# Urgent safety information

## Field Safety Notification (FSN)

### Product recall

Customized sets & treatment units  
of the company Hell & Co. GmbH

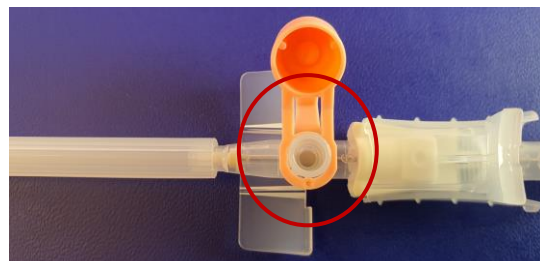
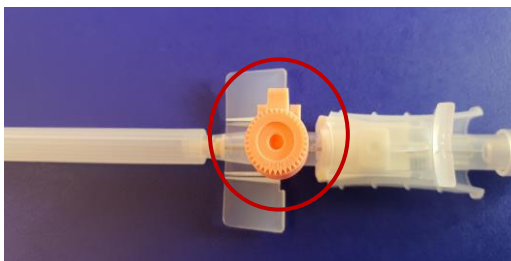
*The root cause identified by BD for reported leaks at the injection port of the BD Venflon Pro Safety cannulae, was identified as a change made in 2019 to the dimensions of the injection port valve (see figures). This change was made to allow for EO sterilisation..*

*If leakage from an injection port remains undetected for a prolonged period of time, this can have critical clinical consequences for the patient.*

*Due to possible blood loss or inadequate infusion of fluids and medications, this can lead to serious harm, life-threatening conditions or even death.*

As a corrective measure by BD, the sterilisation process was changed from ethylene oxide (EO) to electron radiation (E-Beam).

- With immediate effect, Venflon Pro Safety (VPS) safety intravenous catheters, in sets and treatment units, will no longer be configured, packaged and sterilised in an ethylene oxide sterilisation process..
- All Venflon Pro Safety (VPS) safety intravenous catheters still in stock and affected by the recall have been identified and secured in the restricted warehouse for destruction as required by BD.
- Identification and recall of sets and treatment units containing Venflon Pro Safety (VPS) safety indwelling cannulae affected by the recall.
- Creation of an additional warning notice, which is issued to the affected customers together with the safety information.
- Separate labelling of transport boxes containing sets and treatment units affected by the recall. In addition, a warning notice is attached here.
